Las Vegas Water Pollution Control Facility

ODOR CONTROL AT HEADWORKS AND PRIMARY CLARIFIERS

ELECTRICAL

| DRAWING NO. | E-4      |

A PLANTS 1 & 2 GRIT CHAMBERS AND SEDIMENTATION BASINS (SEE NOTES)

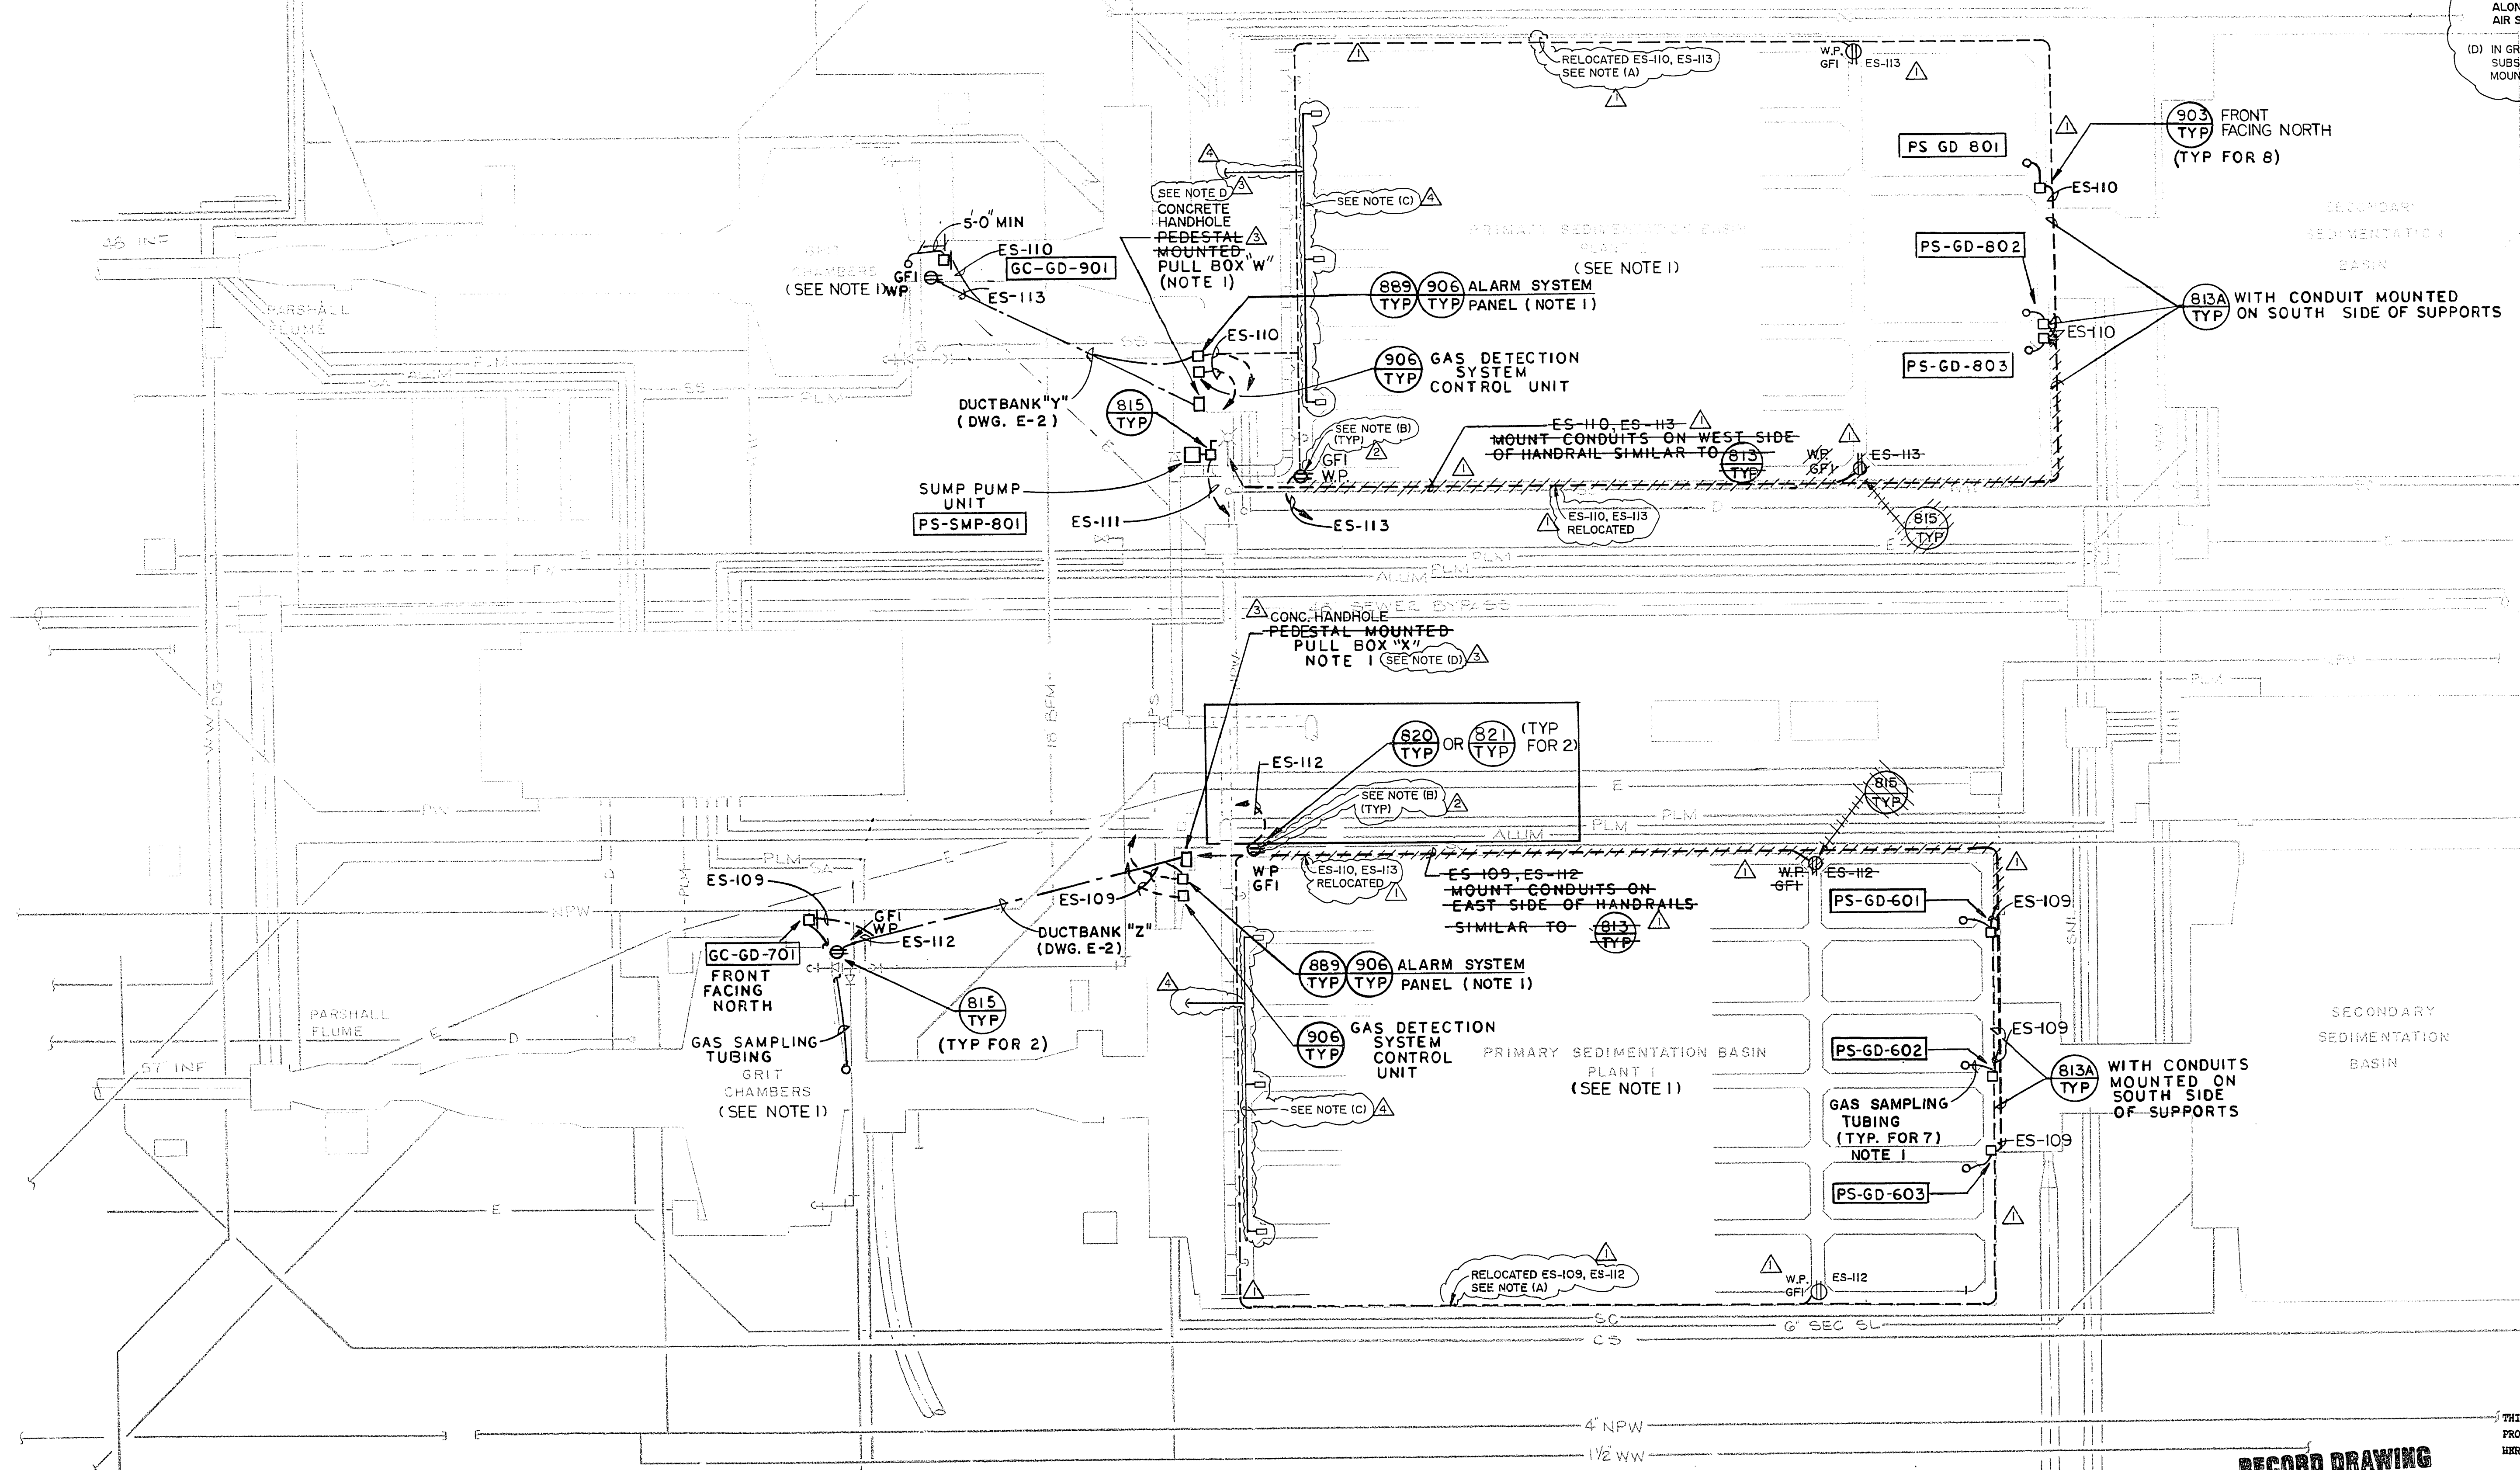
- (A) HANDRAIL IS REMOVED AND ELECTRICAL CONDUIT HAS BEEN REROUTED TO RUN ALONG THE BOTTOM SIDE OF THE FOUL AIR SUPPORTS. (TYP OF 2)
- (B) OUTLET RECEPTACLES HAVE BEEN MOUNTED PER 815 TYP
- (C) NEW FEEDERS TO THE COLLECTIVE DRIVE UNITS ARE FED FROM OVERHEAD ALONG THE BOTTOM SIDE OF THE FOUL AIR SUPPORTS.
- (D) IN GROUND CONCRETE HANDHOLES ARE SUBSTITUTED IN PLACE OF PEDESTAL MOUNTED PULLBOXES.

| YBIA    |      |      |     |                                                 |  |
|---------|------|------|-----|-------------------------------------------------|--|
| YOL-1EB |      | 3/95 | AMS | PCH #24 - REROUTE CONDUIT FOR SED. DRIVE MOTORS |  |
| YOL-1EP |      | 3/95 | AMS | INSTALLED CONC. HANDHOLES IN LEU OF METAL PB'S  |  |
|         |      | 3/95 | AMS | MOUNT OUTLETS ONTO STANDS/HANDRAIL REMOVED      |  |
|         |      | 3/95 | AMS | REROUTE CONDUITS ON TO FOUL AIR SUPPORTS        |  |
